City of Newton, Massachusetts
Department of Planning and Development
1000 Commonwealth Avenue Newton, Massachusetts 02459

MEMORANDUM

RE: **#88-20 Discussion and review relative to the draft Zoning Ordinance**
DIRECTOR OF PLANNING requesting review, discussion, and direction relative to the draft Zoning Ordinance.
Other docket items to be taken up within the context of Zoning Redesign include #30-20, #38-20, and #148-20

MEETING: October 1, 2020

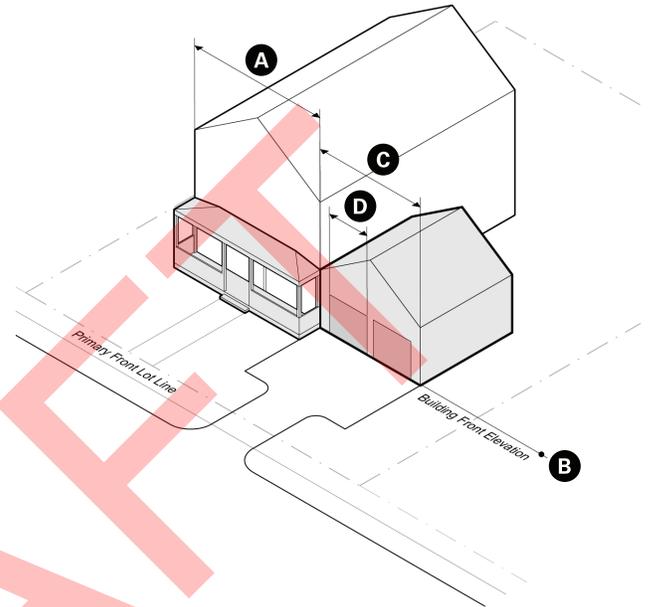
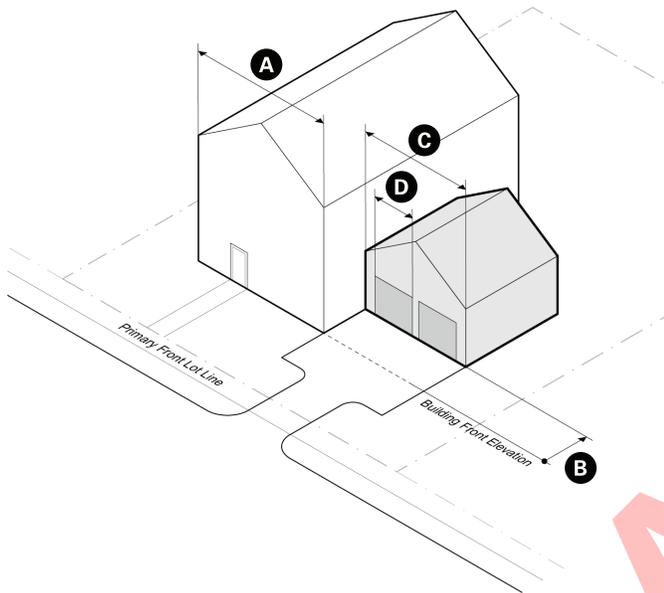
Q: Section 3.4.2.D claims that a garage set back 10' from front elevation and may not exceed 50% of the building front. This is good design practice when the front door takes precedence. How was 10' chosen? Is this a standard?

A: The latest draft recommends that a Front Facing Garage be set back a minimum of 8 ft from the Front Elevation (Sec. 3.4.2.D.a), which aligns with the standard requirements for the Side Wing Building Component. This is not a standard per se. The requirement to offset the garage from the Front Elevation of the building is to limit the visual impact. This recommendation was reviewed by the local architects and builders group.

Attached Garage: Side-Facing

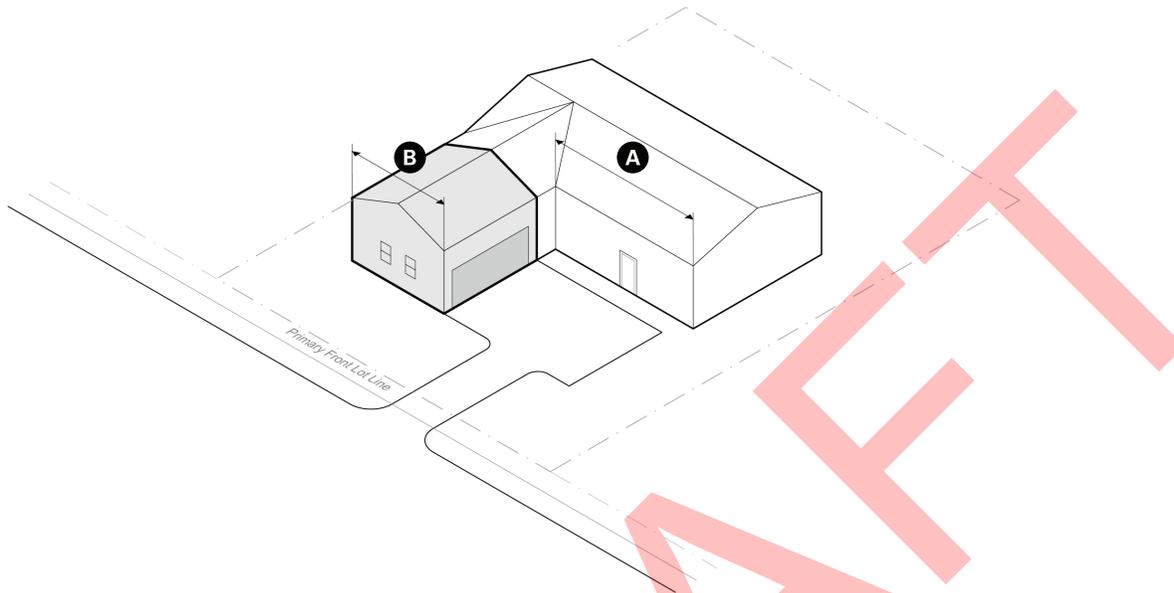
Q: Why only side facing garages on narrow lots? And what constitutes a “narrow lot”?

A: Side Facing garages are allowed on all lots. There is no definition for a “narrow lot” within the proposed ordinance.

Lot with eight residential units or less

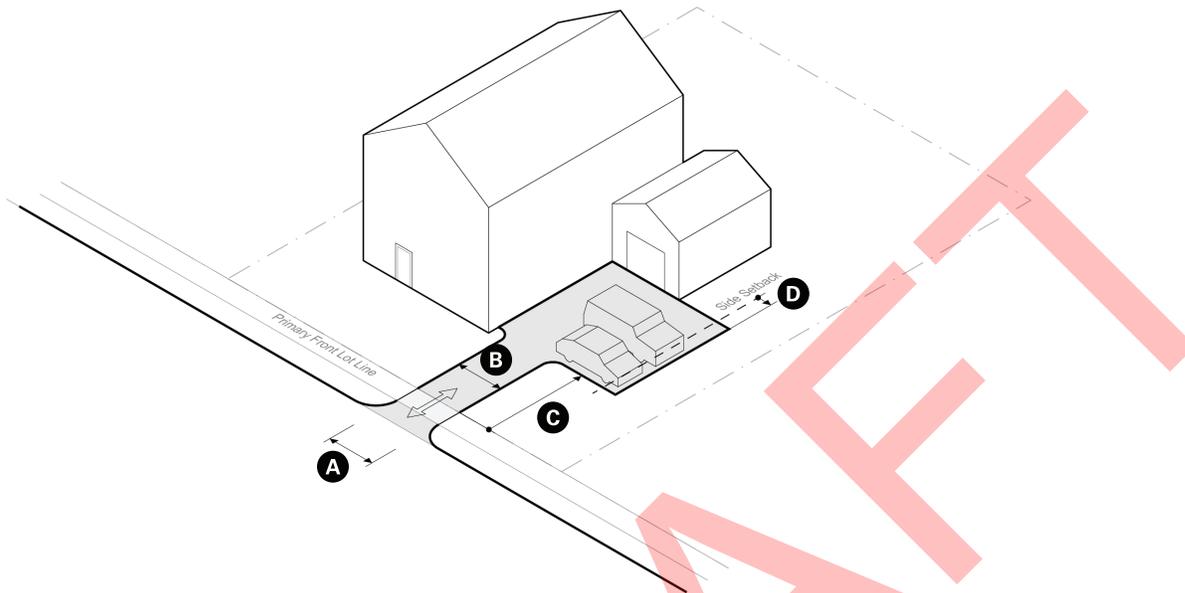
Q: My understanding is that you are recommending that the entrance to a driveway be no greater than 10 feet at the entrance and that this 10 foot width be extended 10 feet into the property from the edge of the sidewalk nearest the property line. Is that correct?

Q: Section 3.7.1.E.7 says that 2 curb cuts have to be 35’ away from each other. Where did the number 35’ come from? Is this a standard?

A: The latest draft recommends that one-way driveways be restricted to a maximum of 10 feet at the property line and for 10 feet beyond the property line into the site for properties in the R1 and R2 districts. Because of the smaller front setback requirements in R3, R4, and N the proposed distance is reduced to 5 feet beyond the property line. The property line does always correspond to the edge of the sidewalk. The curb cut is restricted to a maximum of 12 feet for one way-driveways.

A: Note: In the latest draft this refers to Sec. 3.7.1.E.8. The 35-foot distance between two curb cuts was provided by our consultant and reviewed by ISD and Engineering. 35 feet allows for two standard cars to be parked between the two curb cuts and it provides a sizeable “safe zone” for pedestrians between each curb cut.
